EDWIN I. HATCH NUCLEAR PLANT UNIT NO. 1

AMENDMENT TO FACILITY OPERATING LICENSE

Amendment No. 48  
License No. DPR-57

SAFETY EVALUATION BY THE OFFICE OF NUCLEAR REACTOR REGULATION

Figure 1 - Existing LPCI System

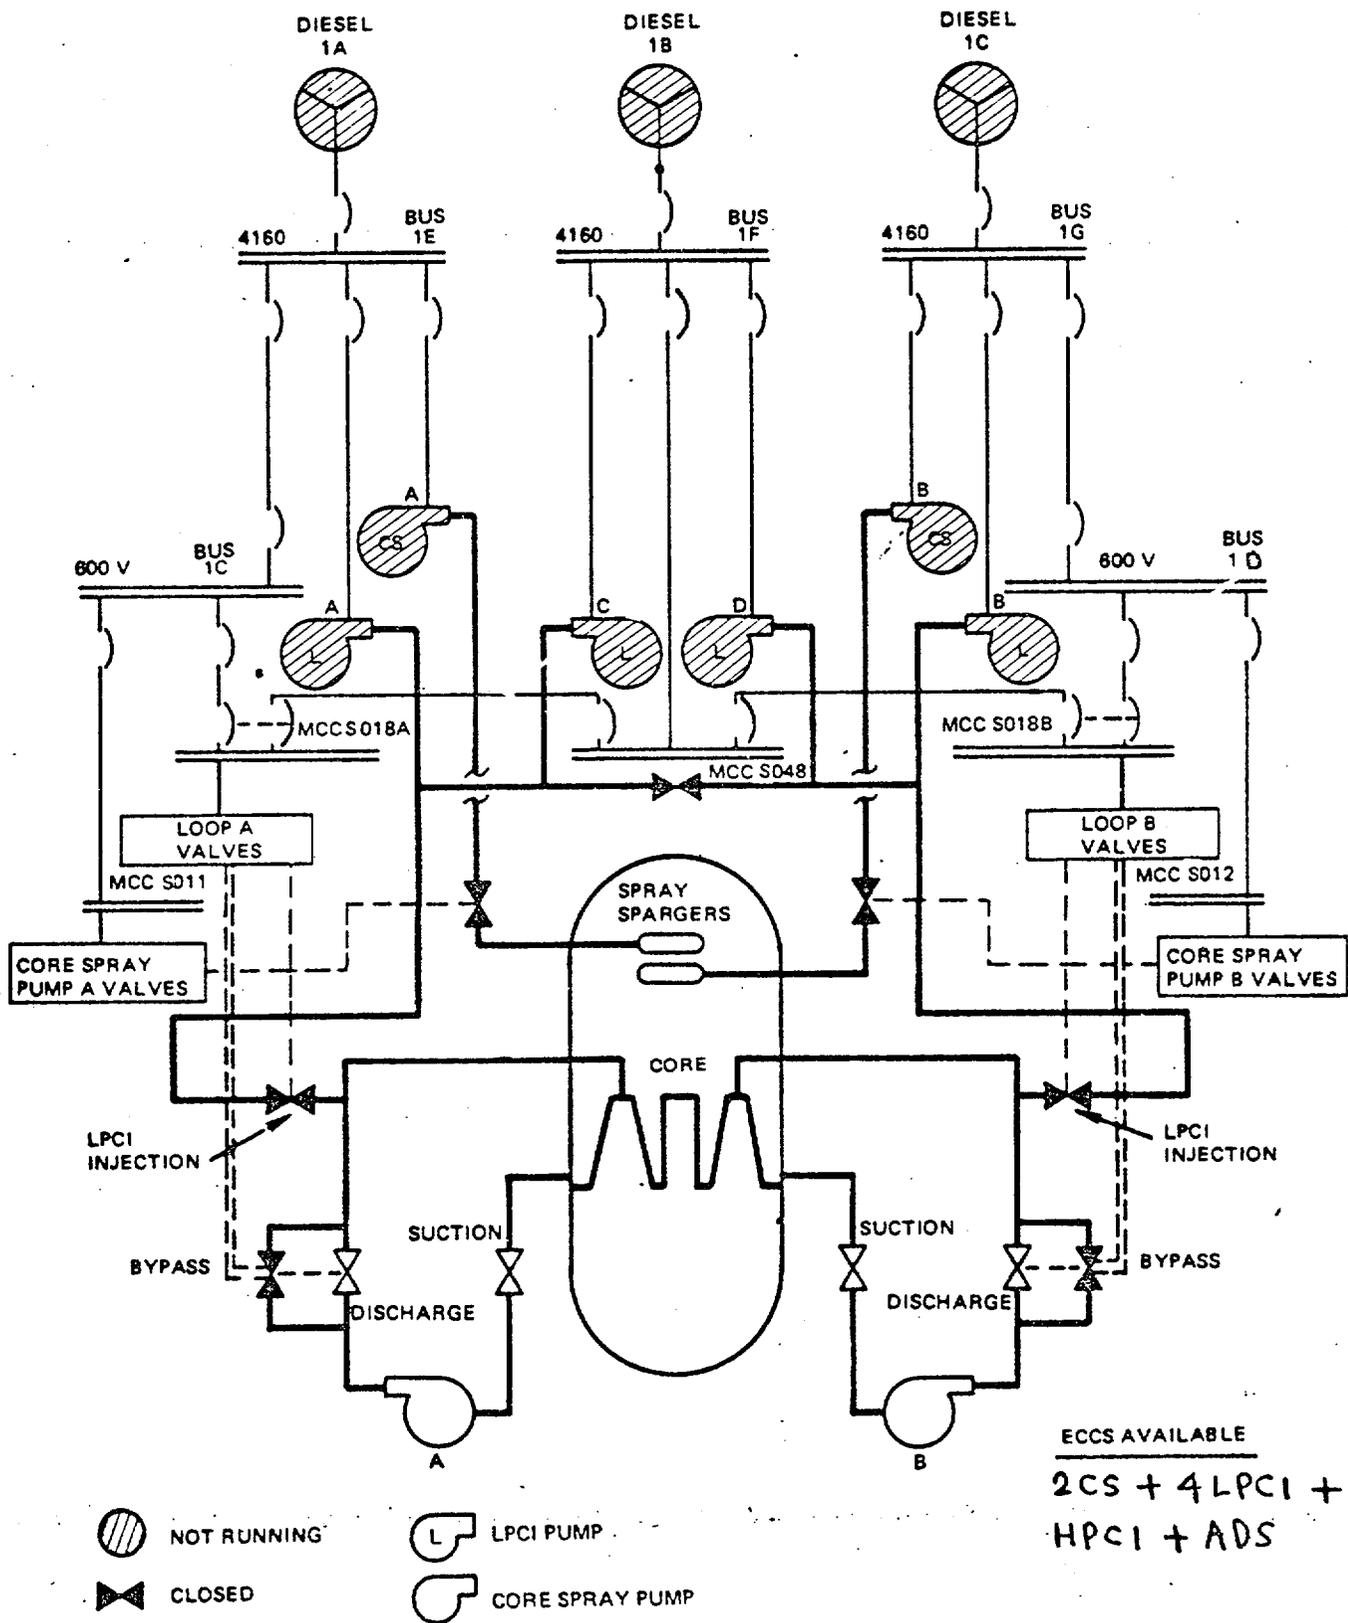
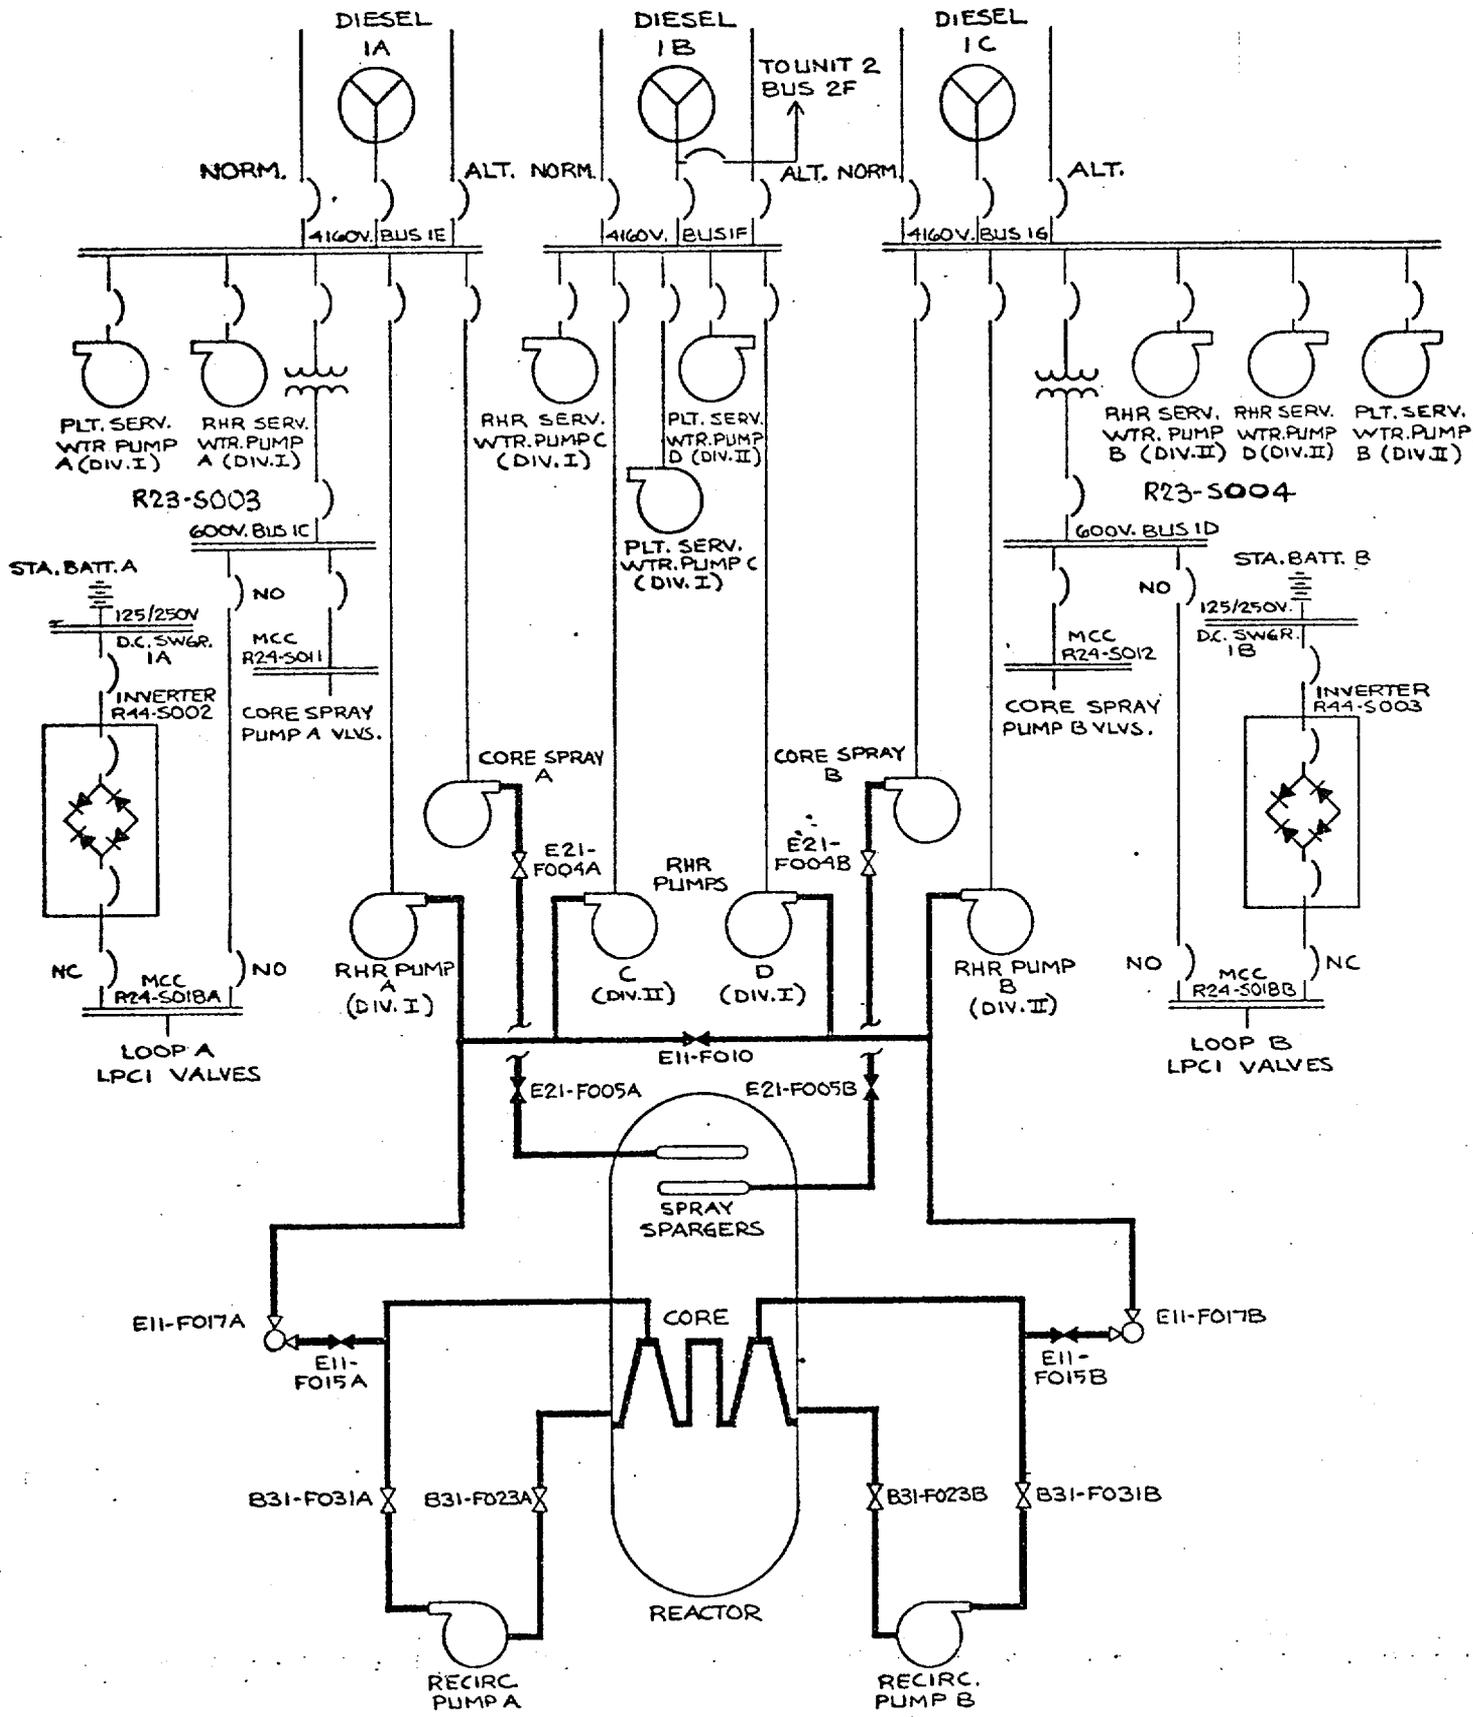
In the existing LPCI system (Figure 1), power to the LPCI injection valve and reactor recirculation pump discharge valve motor operators is supplied from motor control centers (MCCs) S018A and S018B. Motor Control Center S018A supplies the Loop A valve operators and S018B supplies the Loop B valve operators. Normally, MCC-S018A is supplied by 4160 volt AC Bus 1E (Diesel Generator 1A bus) through 600 volt AC Bus 1C, and MCC-S018B is supplied by 4160 volt AC Bus 1G (Diesel Generator 1C bus) through 600 volt AC Bus 1D. The alternate supply for MCCs S018A and S018B is from 600 volt AC MCC S048 which in turn is supplied from 4160 volt AC Bus 1F (Swing Diesel Generator 1B Bus).

The LPCI valve operators in the modified LPCI system will be supplied by MCCs R24-S018A and R24-S018B (Figure 2). MCC R24-S018A will supply the Loop A motor operated valves (MOVs) which include the Reactor Recirculation Pump A Suction and Discharge MOVs, the LPCI Inboard MOV and the Reactor Heat Removal (RHR) Pump minimum Flow Bypass MOV and MCC R24-S018B will supply the Loop B MOVs.

Primary power for MCC R24-S018A is supplied from Station Battery 1A through the 250 volt DC/600 volt AC inverter R44-S002. The alternate supply for R24-S018A will be from the 600 volt AC Bus 1C (R23-S003). Similarly, the primary power for MCC R24-S018B is supplied from Station Battery 1B through inverter R44-S003, with the alternate supply being available from 600 volt AC Bus 1D (R23-S004).

In the modified LPCI system, GPC has eliminated MCC S048 which was supplied power from 4160 volt AC Bus 1F (the Swing Diesel Generator 1B bus). This motor control center was the alternate source of power for MCCs S018A and S018B. MCCs S018A and S018B are modified to be supplied by Station Batteries 1A and 1B, respectively, through corresponding 250 volt DC/600 volt AC inverters R44-S002 and R44-S003. The capacity of the station batteries will be increased to accommodate the load requirements of the associated inverters. The alternate sources to MCCs R24-S018A and R24-S018B will be 600 volt AC Buses 1C and 1D, respectively. The alternate source will be used only during maintenance outages of the inverter, DC switchgear, or the station battery. No automatic transfer between normal and alternate supplies will be required or provided. Auxiliary contacts of both normal and alternate breakers at the MCCs will be interlocked to prevent the closing of the alternate supplies simultaneously.

All breaker control and indications associated with the modified power system will be located in the main control room. Alarms will be provided in the main control room to indicate normal feeder breaker tripped and alternate feeder breaker tripped for each MCC. Alarms will also be provided to indicate inverter trouble such as logic failure, power fuse blown, DC under/over voltage, AC under/over voltage, overload, abnormal frequency, fan failure, AC or DC filter fuse blown and power supply failure.

- (1) The proposed modifications to the LPCI system will assure that the relevant sections of the onsite power system are in conformance with requirements of the NRC and the recommendations of Regulatory Guide 1.6. This has been accomplished by the elimination of the provision for automatically transferring loads between redundant power sources and by providing separate and redundant power supplies and load groups. Further, the loss of a power supply or load group will not prevent the required safety functions from being performed. Therefore, these modifications are acceptable.

Based upon our evaluation above, we conclude that the proposed design modifications and the associated changes to the Technical Specifications are acceptable.
